## Lake Oroville Spillways Emergency Recovery

# Board of Consultants Memorandum No. 12 – September 22, 2017

## Board of Consultants Memorandum

SUBJECT: Memorandum No. 12

Figure 1. Plan and Section showing the original 1960's Emergency Spillway Excavation

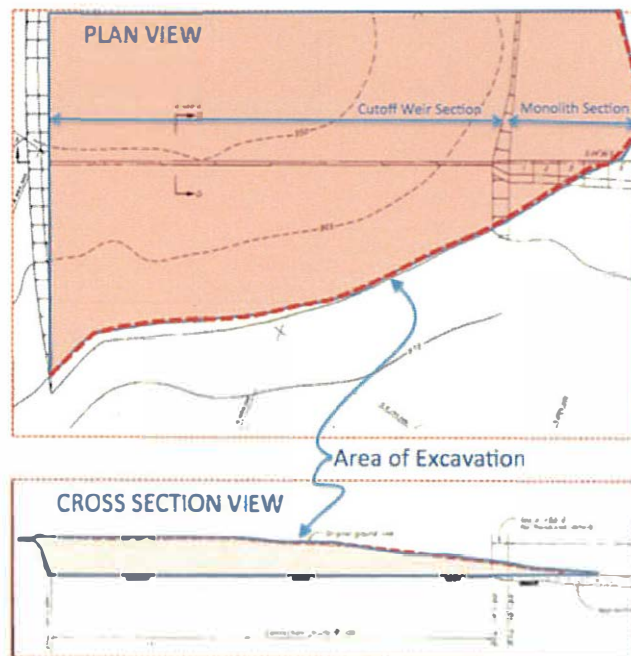
**5. Emergency Spillway Weir Foundation:** During the September 21 field visit, the BOC viewed the foundation excavation for the Emergency Spillway Weir. The original design specified that the subsurface portion be embedded 14 feet into the ground and founded on slightly weathered or fresh rock. The contractor's initial excavation method used a trenching machine that was unable to penetrate the bedrock. Subsequently, an excavator with a hoe ram attachment was used to perform the foundation excavation. This resulted in a wider than planned foundation (approximately 6 to 7 feet wide instead of 2 feet), but this method was also unable to penetrate to the full 14-foot depth (measured from the top of the weir) with the current depth approximately 6 feet below the natural ground surface. The rock exposed in the foundation bottom is predominately slightly weathered to fresh rock. It should be noted that the current "ground surface" is itself an excavated surface that was created during the original 1960's construction by excavating from 5 to 40 vertical feet of amphibolite rock, and re-contouring a hill to create the approach for this part of the emergency spillway (see Figure 1). The BOC believes that the bedrock currently exposed in this foundation is of sufficient strength and quality to serve as an adequate foundation for the weir, and that requiring the contractor to continue deepening this excavation would not be meaningful.

- M12-5      The BOC believes the bedrock currently exposed in the foundation of the Emergency Spillway weir is of sufficient strength and quality to serve as an adequate foundation for the cutoff weir.

Figure 2. Photos of the downstream end of the existing chute slab showing spalls.

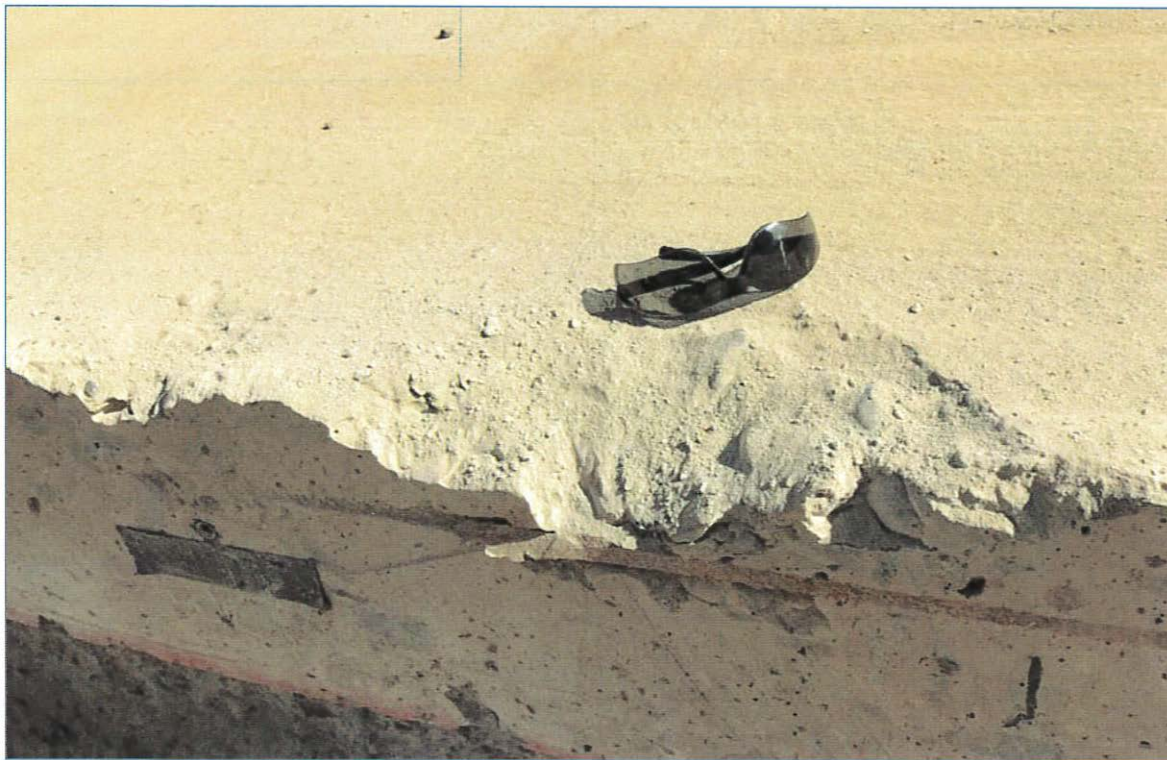
2. The BOC noted during their tour of the FCO Spillway chute that the downstream end of the existing chute slab at Station 20+30 where the connection to the new constructed slabs will be made, has a number of areas of spalled or broken concrete on the top edge. These must be repaired by the best method of concrete patching. Photos showing the spalls along the downstream end of the existing chute slab are provided in Figure 2.

- M12-12 The BOC recommends that the spalled areas along the downstream end of the existing FCO chute slab at Station 20+30 (where the connection to the new constructed panels will be made) be repaired by the best method of concrete patching.
